Appendix E
Agency Consultations

Appendix E-1
DAHP Concurrence on Area of Potential Effects
Applicant APE

Property: *Consultation for Area of Potential Effects Whistling Ridge Energy Project, Skamania County, Washington*

Re: Area of Potential Effects-Concurrence and Comments

Figure 1
Area of Potential Effects
Whistling Ridge Energy Project

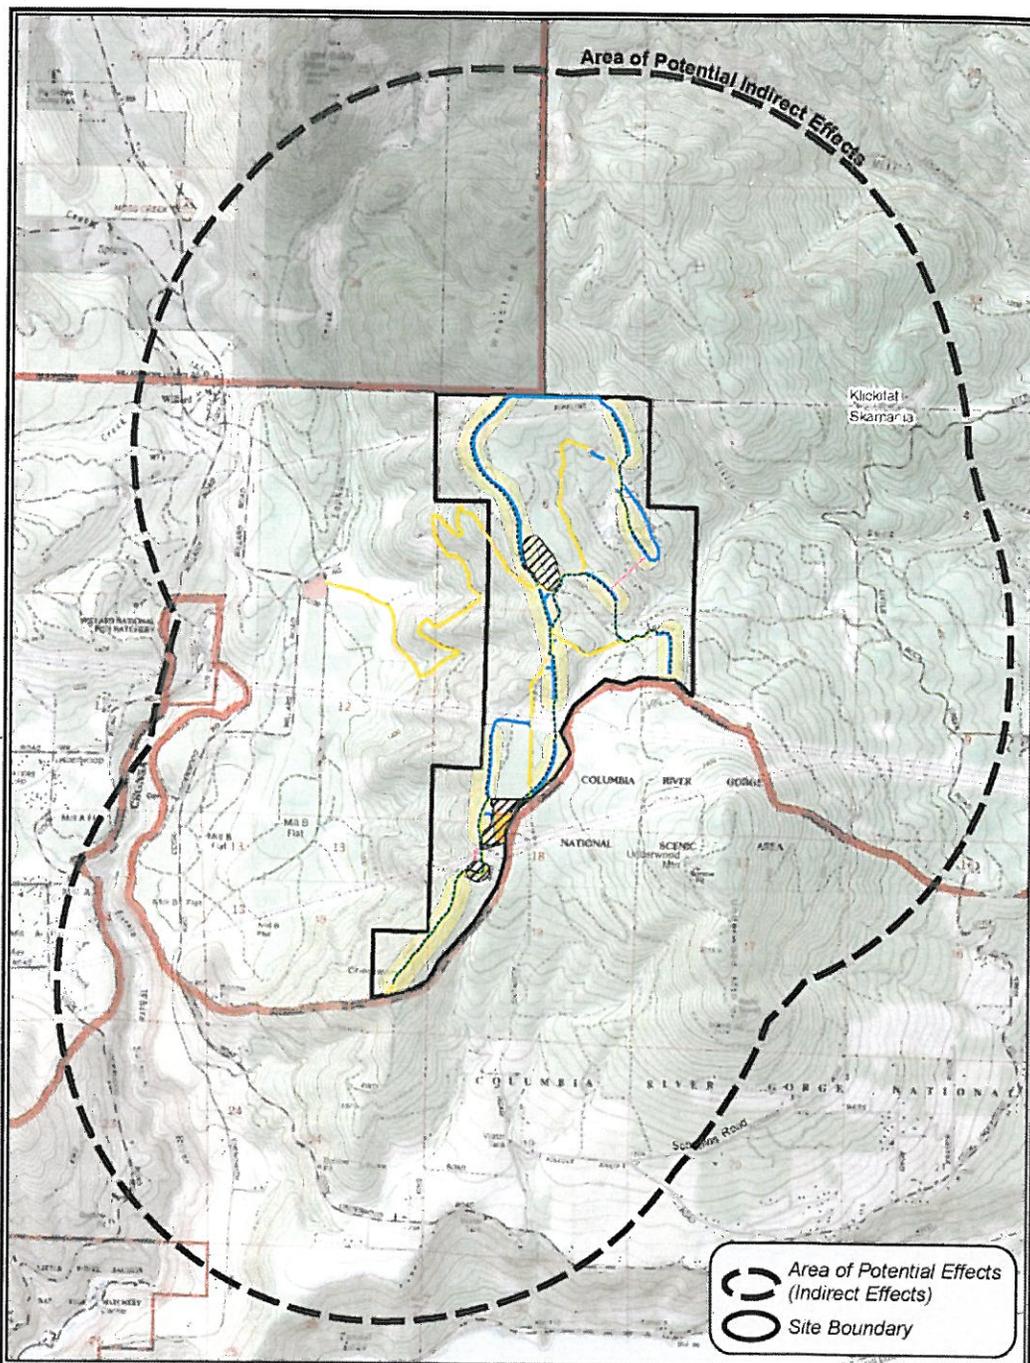
We have reviewed the material you forwarded to our office that describes the area of potential effect (APE) for the Whistling Ridge Wind Energy Project in Skamania County. We concur with the definition of the APE. We look forward to receiving any correspondence or comments from the concerned Tribes or other parties and the cultural resources survey report when it is available.

Proposed BPA Substation - Whistling Ridge Energy Project
 Area of Potential Effects

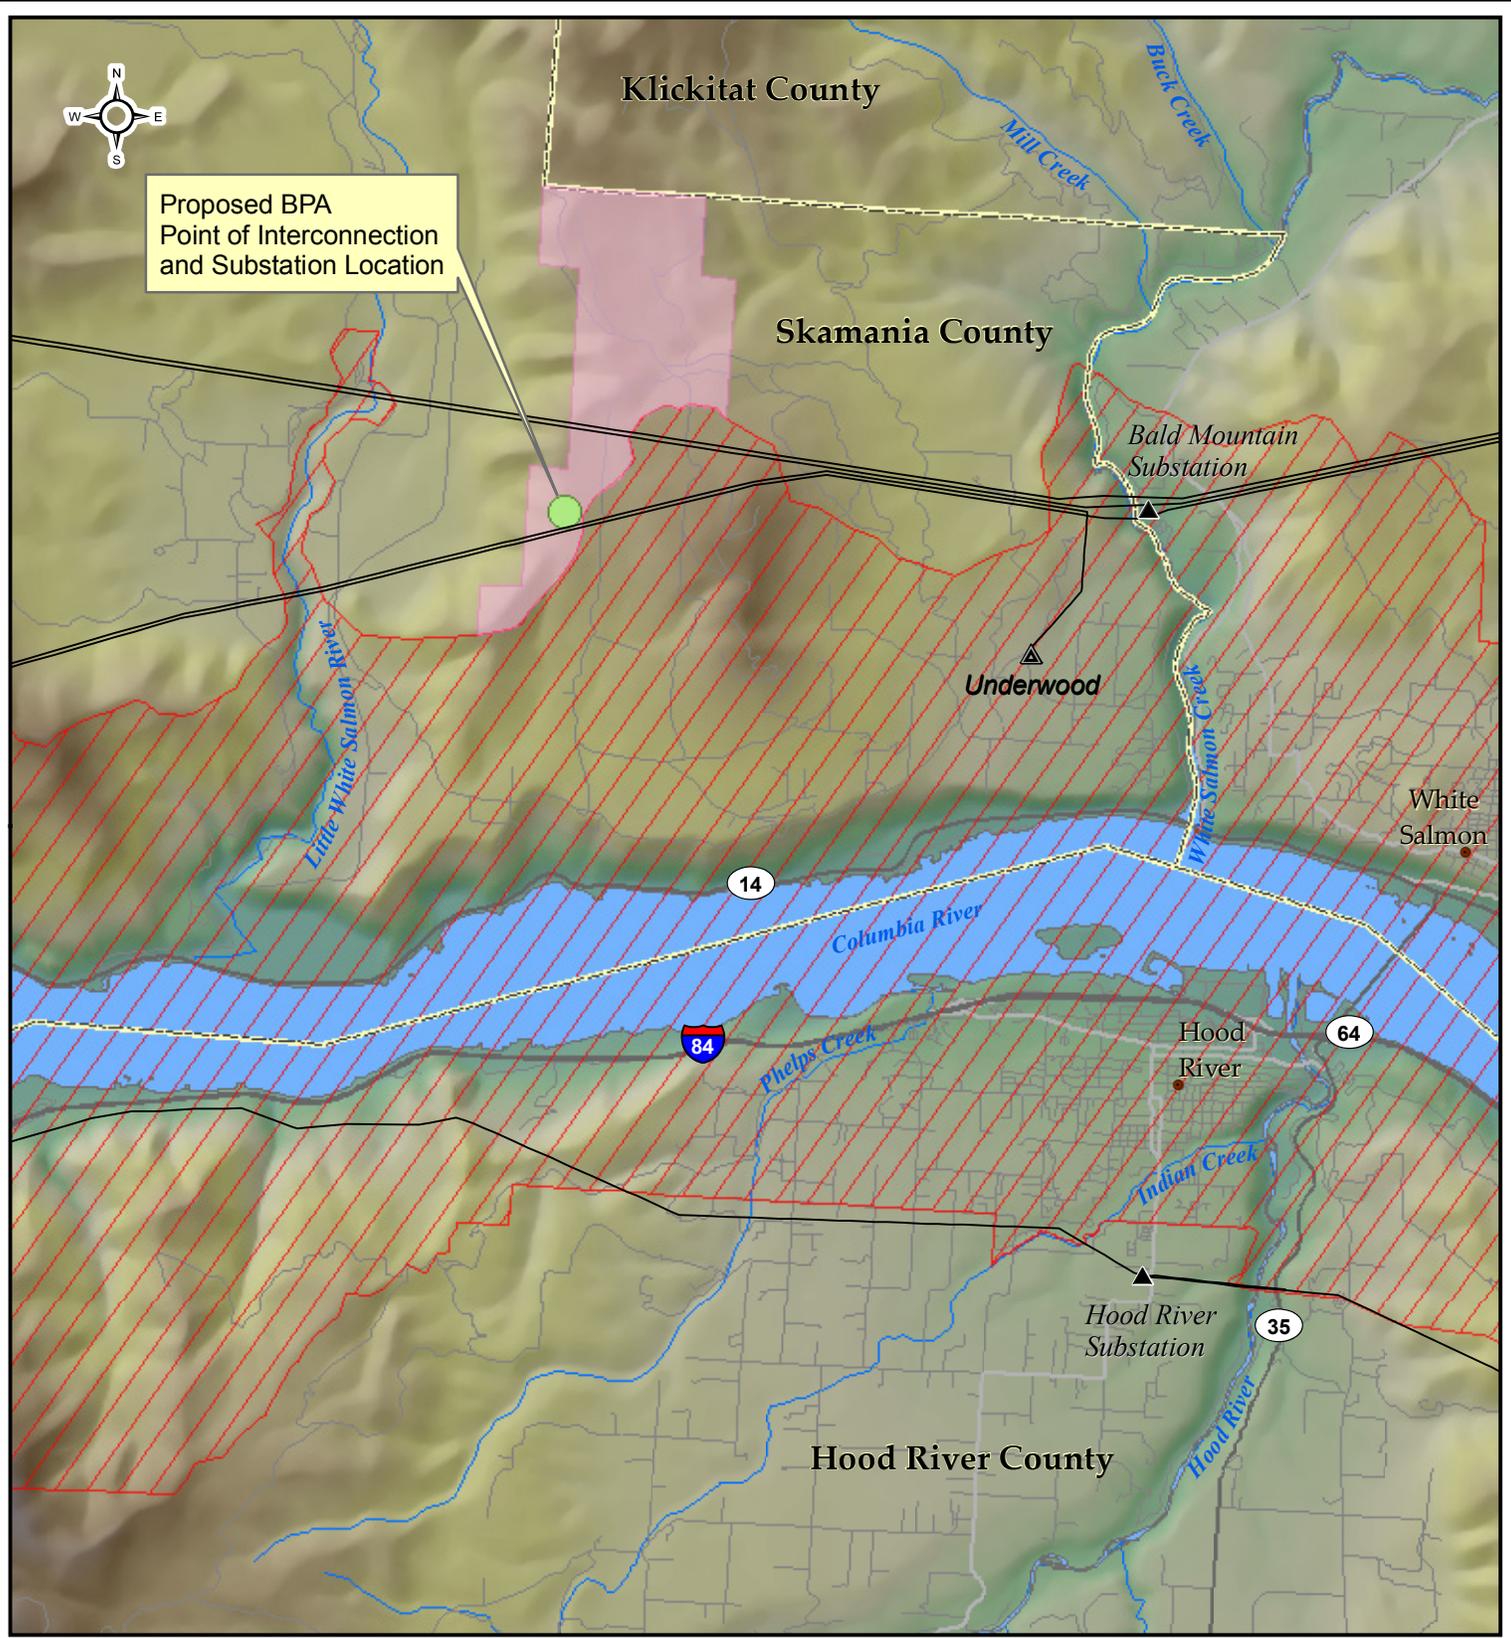
We concur with your determination of the Area of Potential Effect (APE) as described and presented in your figures and text.
